PONTOONS, STEEL, SECTIONAL, P-SERIES
DETAIL SPECIFICATION FOR

MIL-P-19380/1
 AMENDMENT-2
 26 July 1982
 SUPERSEDING
 AMENDMENT 1
 24 AUGUST 1981

PONTOONS, STEEL, SECTIONAL, P-SERIES:
 Detail SPECIFICATION FOR

FIGURE 1 - MATING TEST CONFIGURATION

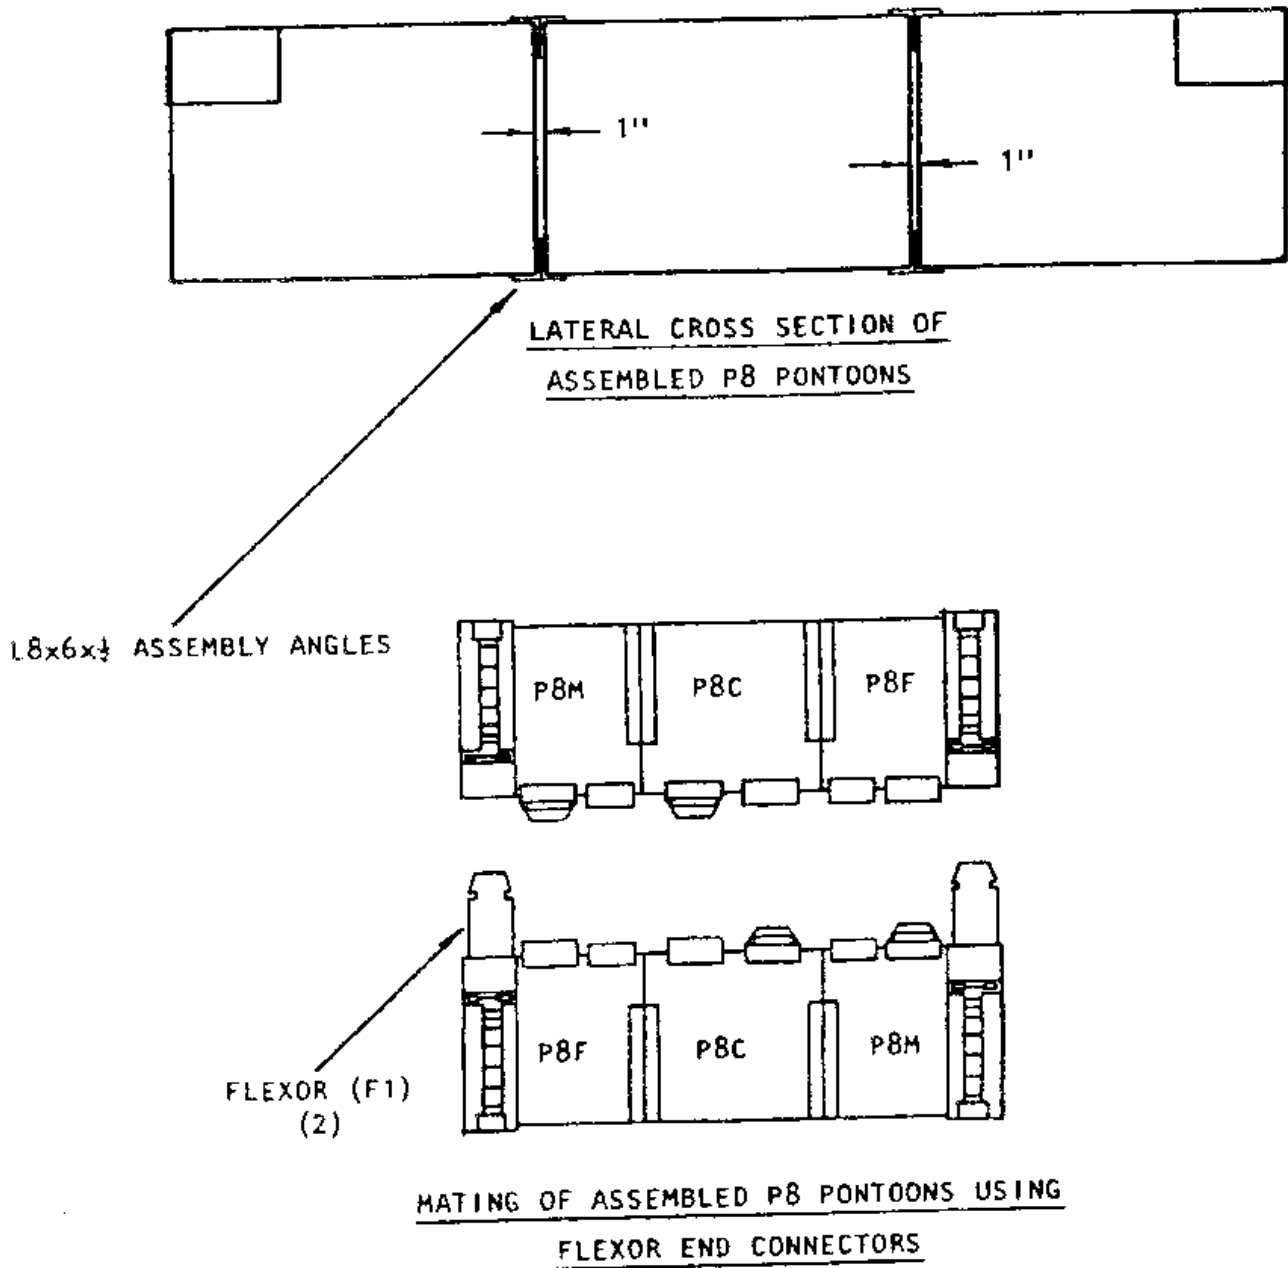
Insert: 4.4.3 Mating test. Unless otherwise specified (see 6.2), two sets of three pontoons each (P8M, P8C, P8F) shall be connected as shown in figure 1 with the flexor connectors installed in the receivers of one set for first article testing. Aline the two connected sets of P8's and join together. Failure of the flexor connectors and pipe and socket devices to match up with, and securely connect to, the appropriate receiver shall constitute failure of this test.

Insert attached figure, "FIGURE 1 - MATING TEST CONFIGURATION" as Page 6.
